## Exhibit H

### Recommended Regional Amendments to the 2018 International Swimming Pool and Spa Code North Central Texas Council of Governments Region

ADD: Figure: 25 TAC §265.186 (e) (6)

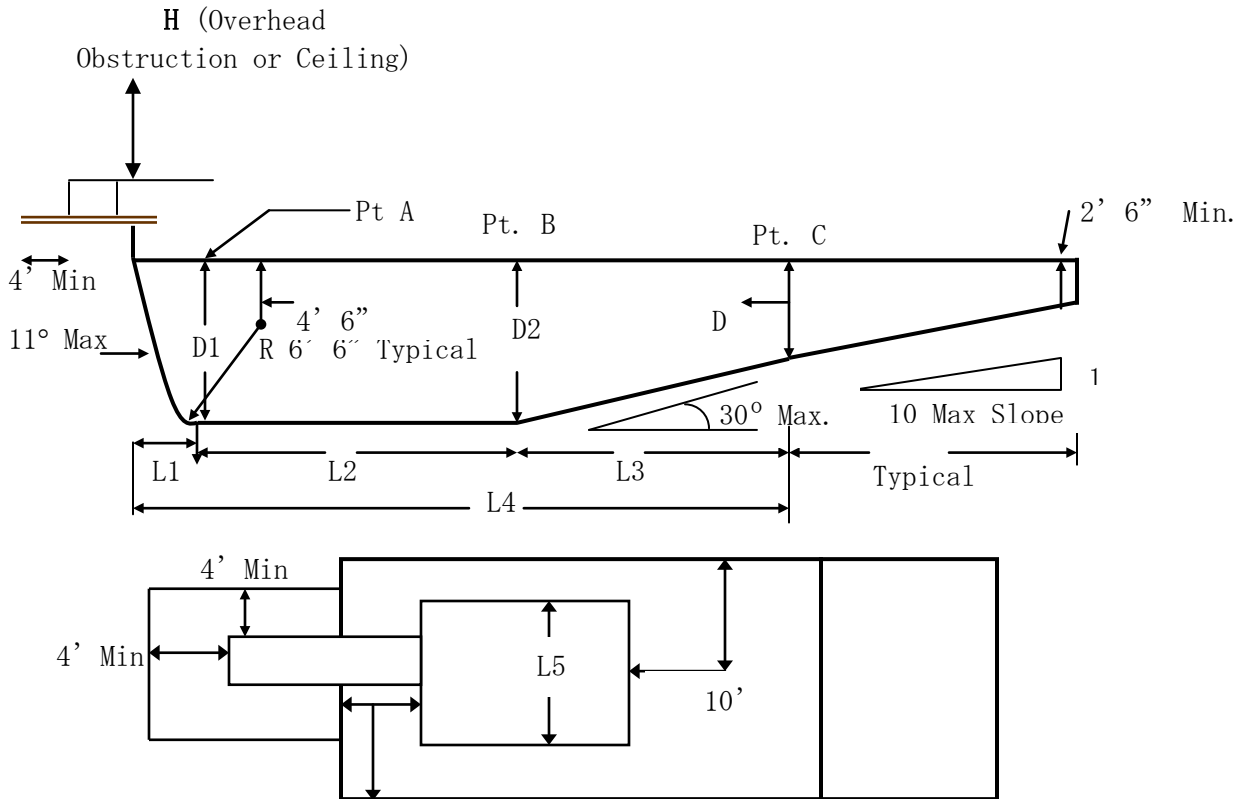
**402.12 Water envelopes.** The minimum diving water envelopes shall be in accordance with Texas department of State Health services, Administrative Code Title 25, Chapter 265, Section 186 (e) and Figure: 25 TAC 256.186 (e) (6). (Delete Table 402.12 and Figure 402.12)

Maximum Diving Board Height Over Water	¾ Meter	1 Meter	3 Meters
Max. Diving Board Length	12 ft.	16 ft.	16 ft.
Minimum Diving Board Overhang	2 ft. 6 in.	5 ft.	5 ft.
D1 Minimum	8 ft. 6 in.	11 ft. 2 in.	12 ft. 2 in.
D2 Minimum	9 ft.	10 ft. 10 in.	11 ft. 10 in.
D3 Minimum	4 ft.	6 ft.	6 ft.
L1 Minimum	4 ft.	5 ft.	5 ft.
L2 Minimum	12 ft.	16 ft. 5 in.	19 ft. 9 in.
L3 Minimum	14 ft. 10 in.	13 ft. 2 in.	13 ft. 11 in.
L4 Minimum	30 ft. 10 in.	34 ft. 7 in.	38 ft. 8 in.
L5 Minimum	8 ft.	10 ft.	13 ft.
H Minimum	16 ft.	16 ft.	16 ft.

From Plumbet to Pool Wall at Side	9 ft.	10 ft.	11 ft. 6 in.
From Plumbet to Adjacent Plumbet	10 ft.	10 ft.	10 ft.
